SERVICE BULLETIN 00134 REV 2.2

Subject: Horizontal Stabilizer Forward Attach Bolt Position

Affected Models: RV-4, RV-6/6A, RV-7/7A, RV-8/8A

FIGURE 1: LONGERON REDUCED EDGE DISTANCE
(HORIZONTAL AND TOP DECK REMOVED)

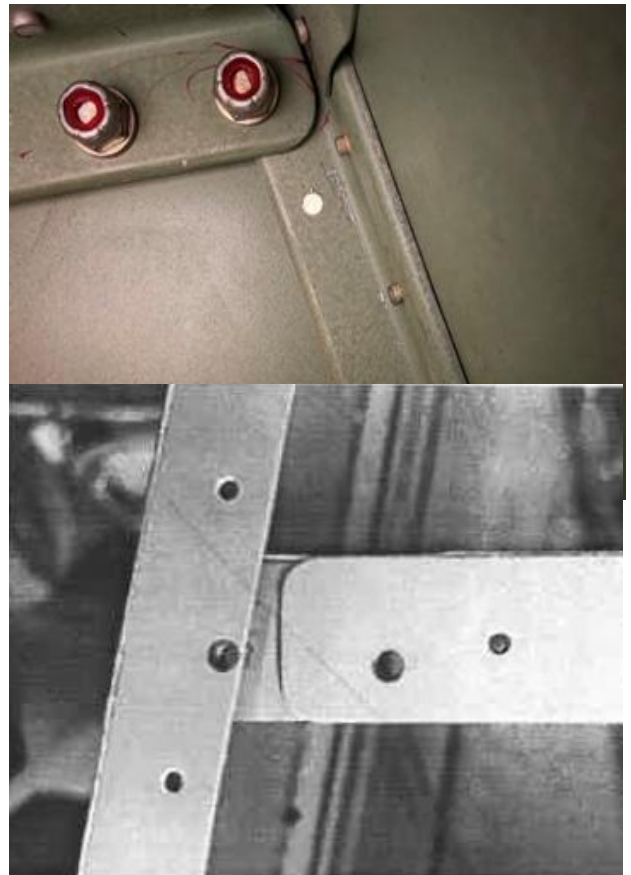
The strength of this joint and the airframe structure as a whole is relatively tolerant of variations in the outermost bolt hole position in the fuselage longerons, even where this involves less than what are normally considered minimum edge distances, zero edge distance and even bolt holes cutting through the inner edge of the longeron flange.

In the fuselage longeron, spanwise locations of the outermost bolt positions that result in the hole for the outboard bolt having a reduced edge margin in the longeron, cutting through the inboard edge of the longeron or missing the longeron altogether are acceptable. See Figure 1.

FIGURE 2: RV-7 DEG 27A TYPICAL HORIZONTAL STABILIZER ATTACH FRONT VIEW

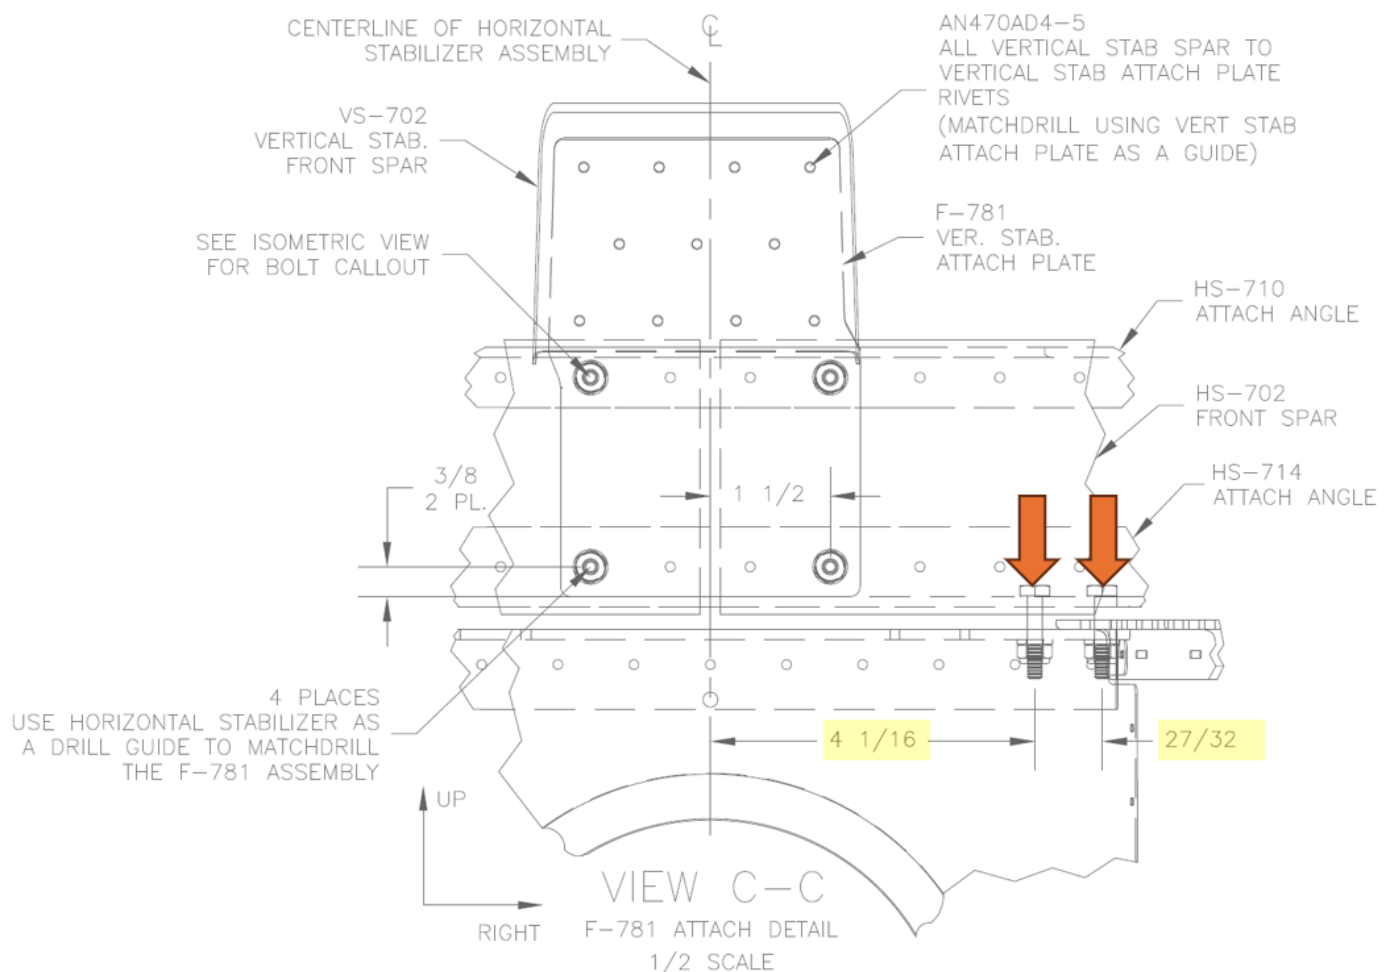
Step 2: Measure the distance between the attach bolts on one side of the aircraft (see the set of bolts marked with arrows in Figure 2 with a distance of 27/32 inches between them). At minimum the distance between the bolts should be 25/32 inches.

Measure the edge distance between the center of each bolt hole and the forward edge of the HS-714 Attach Angle. Repeat the measurement for the forward edge of the F-710B Angle. See Figure 2 and Figure 3. The edge distance should not be less than $e/D = 1.5$ (e/D the distance from the center of a hole to the edge of the part divided by the diameter of the hole $.190 \times 1.5 = .28$ in).

For example, Figure 2 the center of the bolt pattern would be $4 \frac{1}{16}$ inches plus half the distance between the bolts or half of $\frac{27}{32}$ inches which results in a bolt pattern center distance to the centerline of 4.48 inches.

A hole spacing less than 25/32 inches but not less than 1/2 inch is acceptable provided that the areas shown in Figure 6 and the areas between the bolts are carefully inspected at each annual or 100-hour intervals whichever comes first (the relief notch within the red box in the figure and the angle inside radius within the blue box). If the distance is less than 1/2 inch contact Van's Aircraft for further assistance.

An edge distance less than $e/D = 1.5$ (.28 in) but not less than $e/D = 1.0$ (.19 in) is acceptable provided that the areas shown in Figure 6 are carefully inspected at each annual or 100-hour intervals whichever comes first (the relief notch within the red box in the figure and the angle inside radius within the blue box).

If the e/D is less than 1.0 (.19 in) contact Van's Aircraft for further assistance.

FIGURE 4: ACCEPTABLE BOLT POSITION CHART

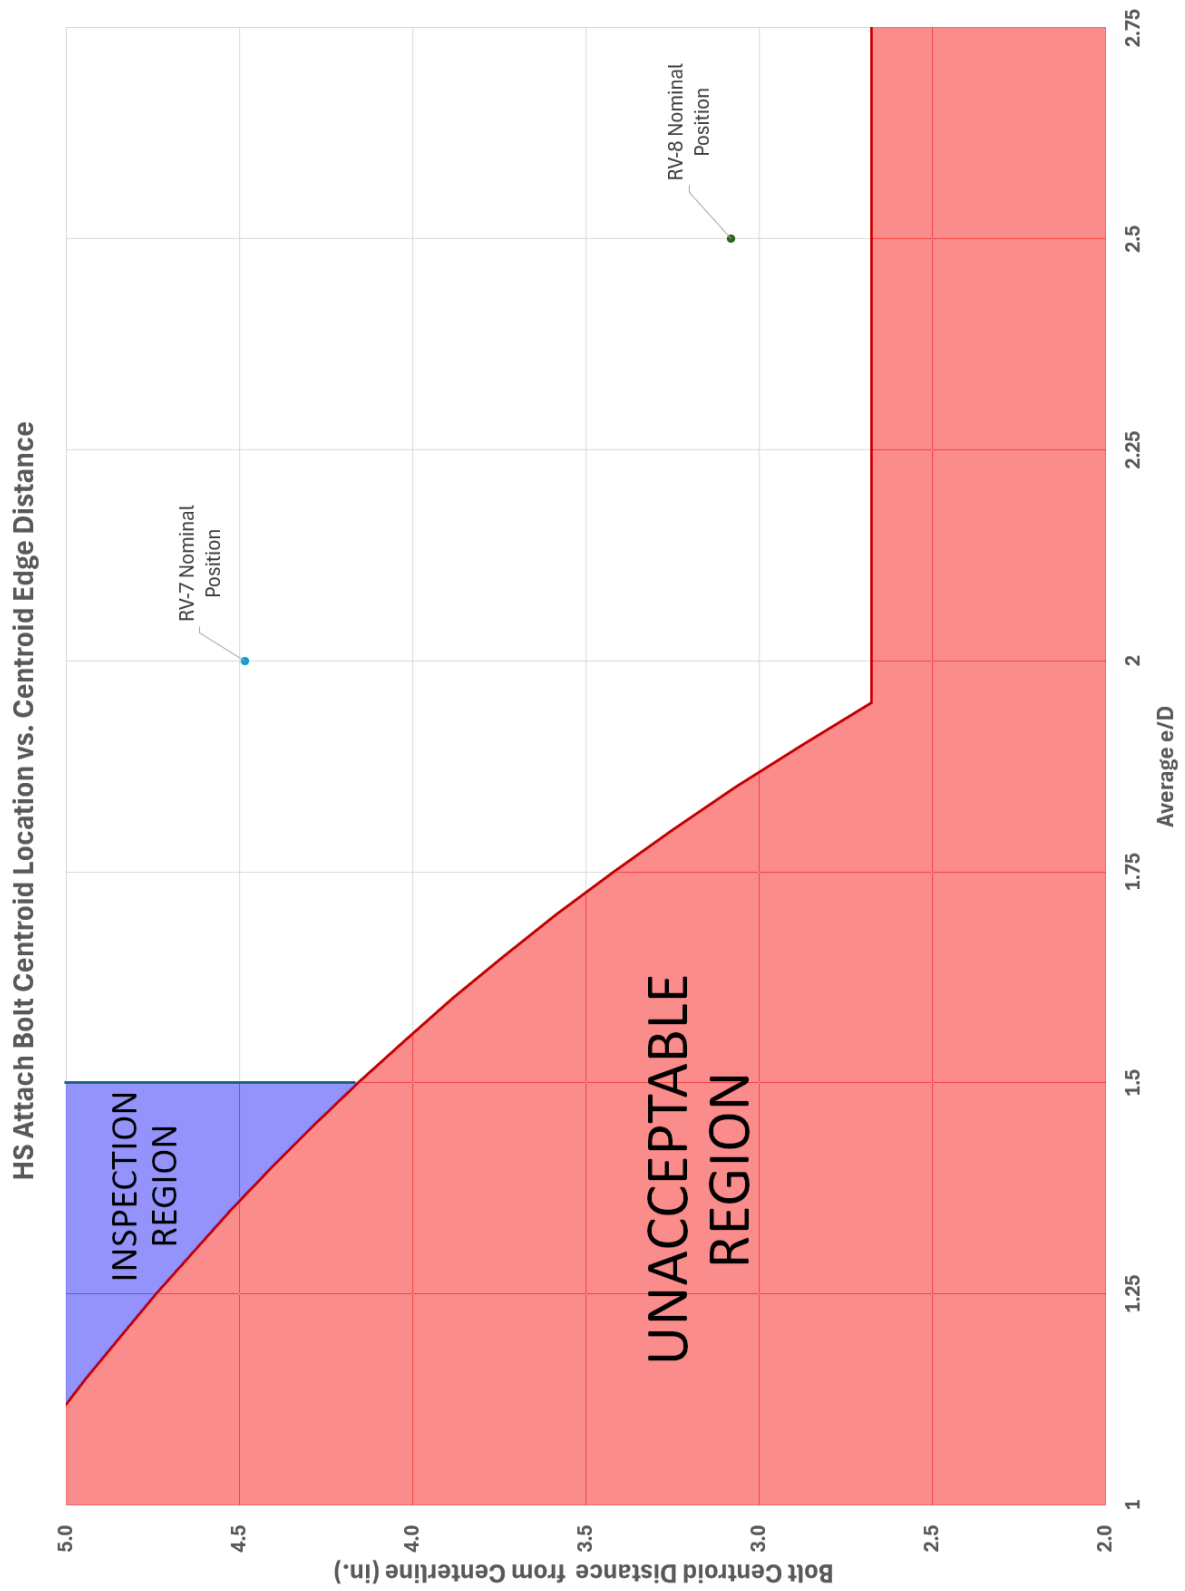
Step 5: Plot the average e/D value for the center of the bolt pattern and the forward edge of the HS-714 Attach Angle from Step 3 and the bolt pattern center distance to the centerline measured in Step 4. The plotted point must be outside the unacceptable region noted in Figure 4.

For example, the bolt pattern distance from Step 4 was 4.484 inches. Assume the nominal e/D of 2 (.38 in) of the center of the bolt pattern. This example corresponds to the RV-7 nominal point given on the chart in Figure 4. If the point on the chart is within the unacceptable area on the chart contact Van's Aircraft for further assistance.

FIGURE 5: OUTBOARD BOLT POSITION & e/D

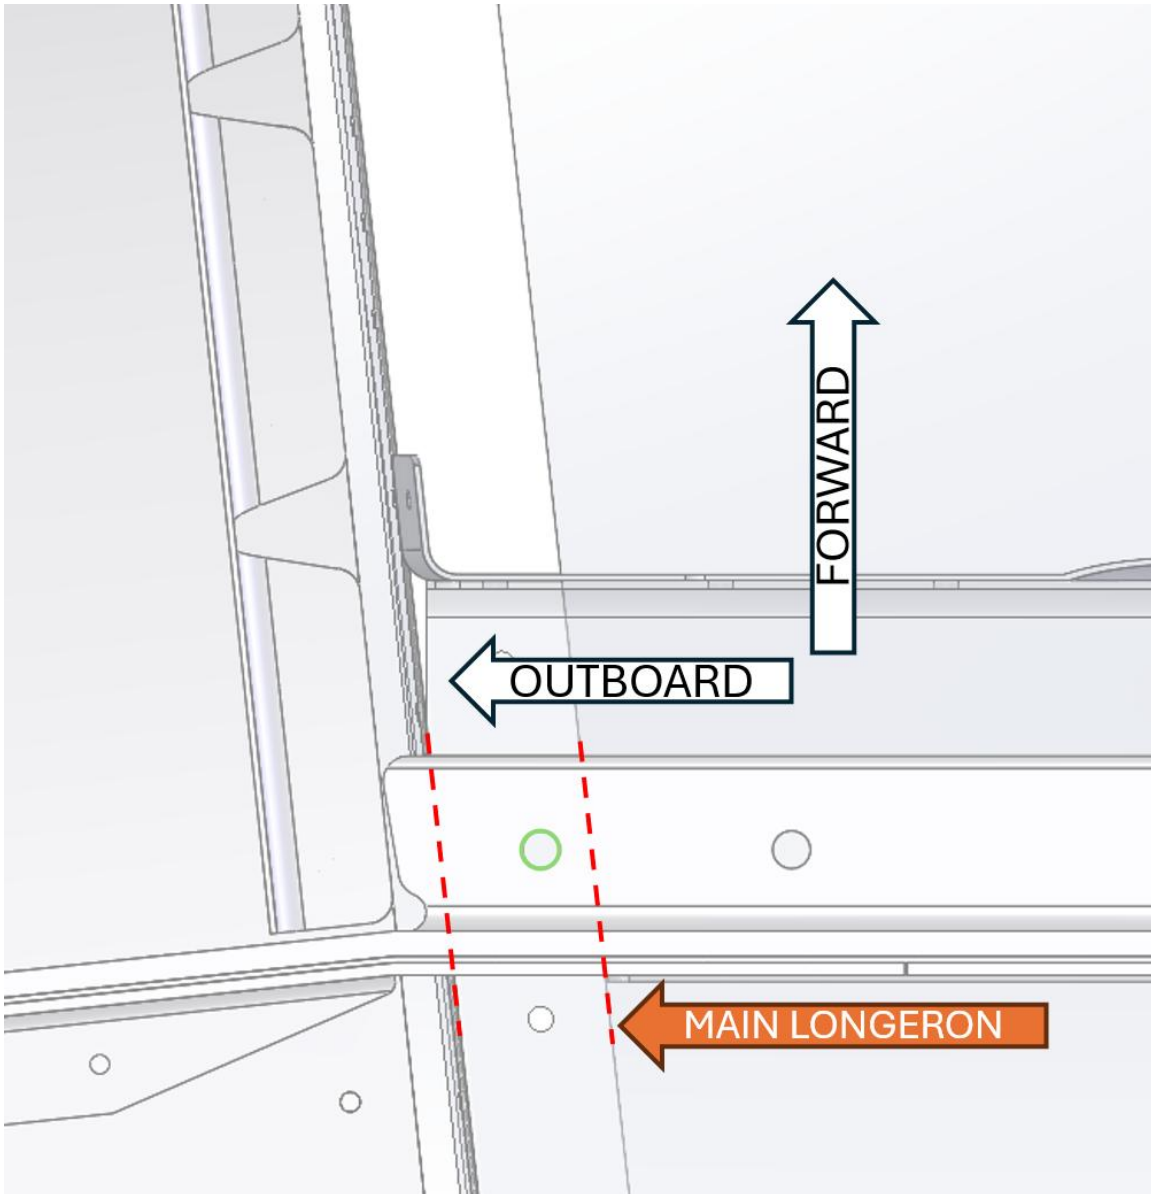
If the entire diameter of the outboard most bolt hole is within boundary of the main longeron (see Figure 5) and if the inboard bolt meets the criteria of Step 3A $e/D = 1.5$ (.28 in) and Step 4 and Step 5 (below) then an edge distance $e/D = .25$ (.05 in) is acceptable.

If the e/D is less than those specified above or the outboard end of F-710B is not resting on the F-718 Longerons, contact Van's Aircraft for further assistance.

FIGURE 6: INSPECTION LOCATIONS

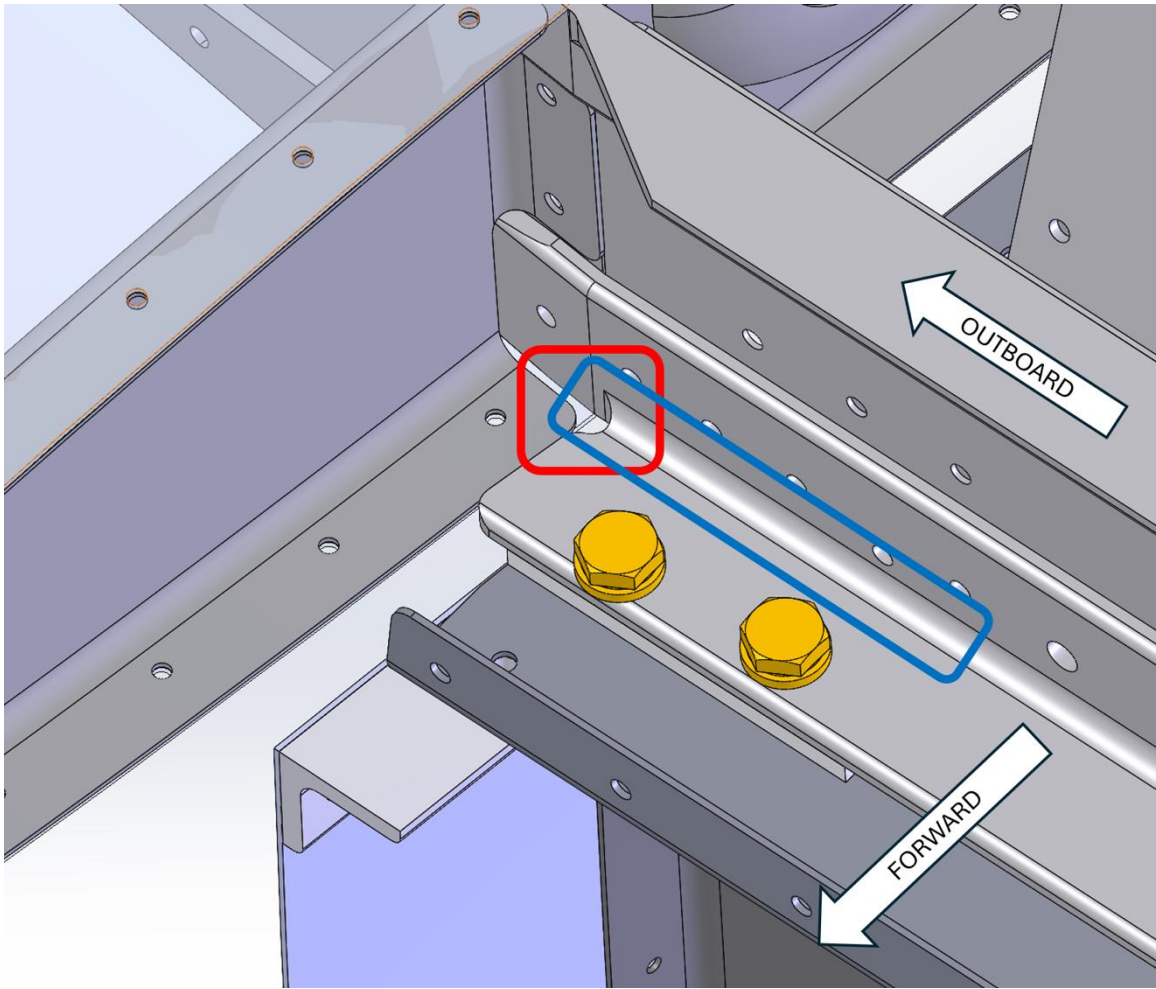
Any trim condition inboard of the trim profile shown within KAI but not greater than the maximum depth and criteria stated above and shown in Figure 9 is acceptable provided that the area within the red box shown in Figure 6 is carefully inspected at each annual or 100-hour intervals whichever comes first.

FIGURE 9: RELIEF NOTCH DETAILS

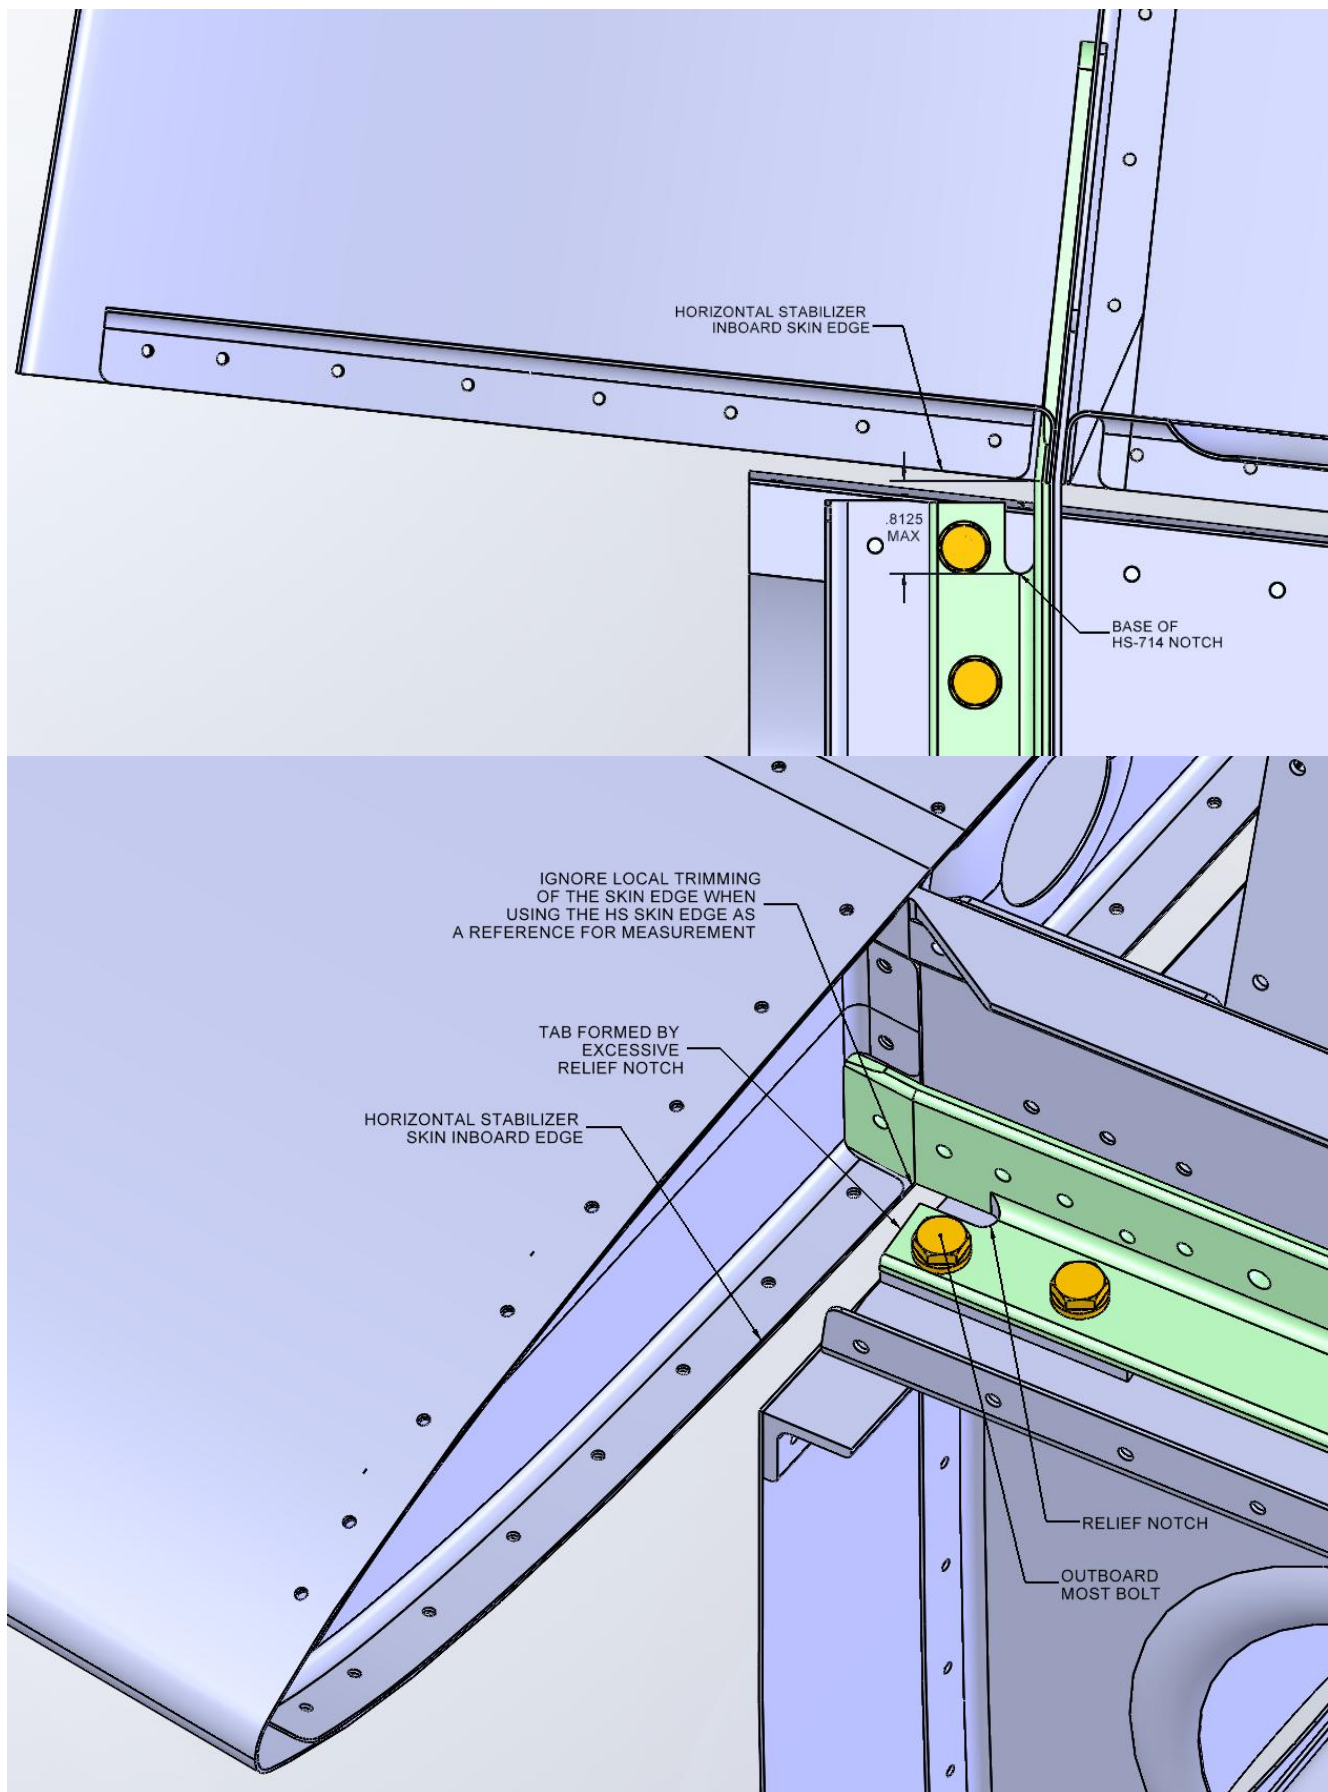
Some notches are excessive and have effectively formed a tab on which the outboard most attach bolt is positioned as shown in Figure 9. This is permissible if the inboard edge of the notch meets the criteria above.

FIGURE 10: WASHER PLATE

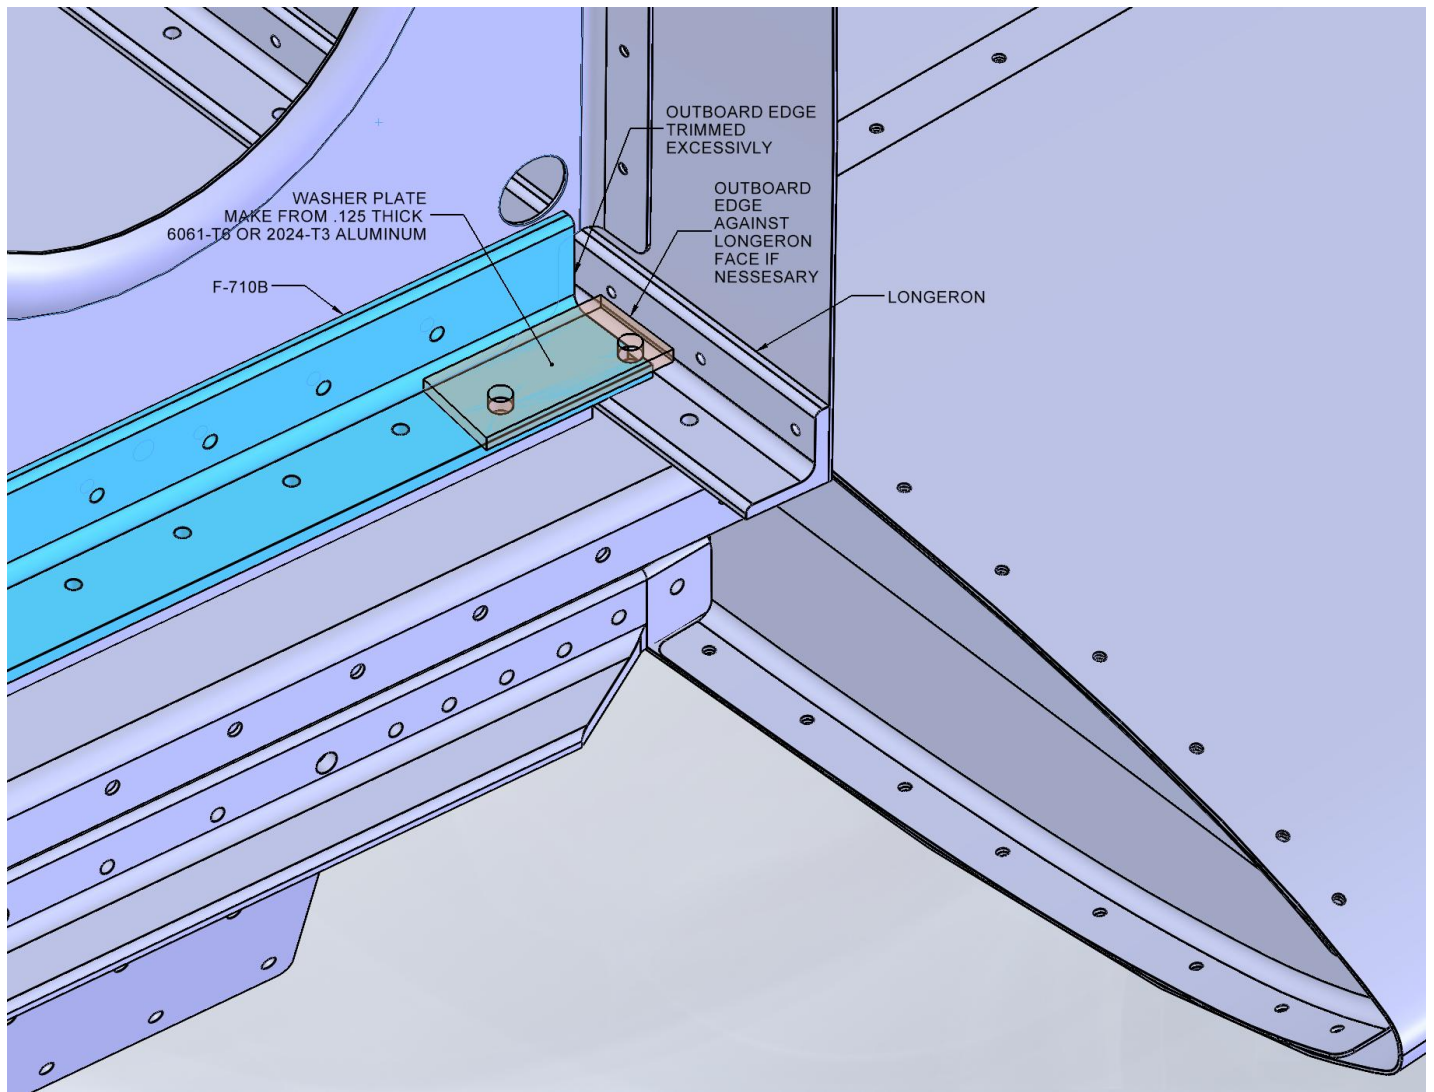
For e/D 's less than .875 (.17 in) and equal to or greater than .25 (.05 in) a washer plate capturing both bolts shall be installed. See Figure 10. The plate shall be made from .125 thick 6061-T6 or 2024-T3 aluminum. The plate shall have at minimum an $e/D = 1.0$ (.19 in) spanwise edge distance for the outboard most bolt and maintain a 1.5 (.28 in) to 2 (.38 in) e/D elsewhere. The plate must rest in full contact with the flat area of F-710B it not be held off by the fillet radius of the F-710B, rivet heads or other features.
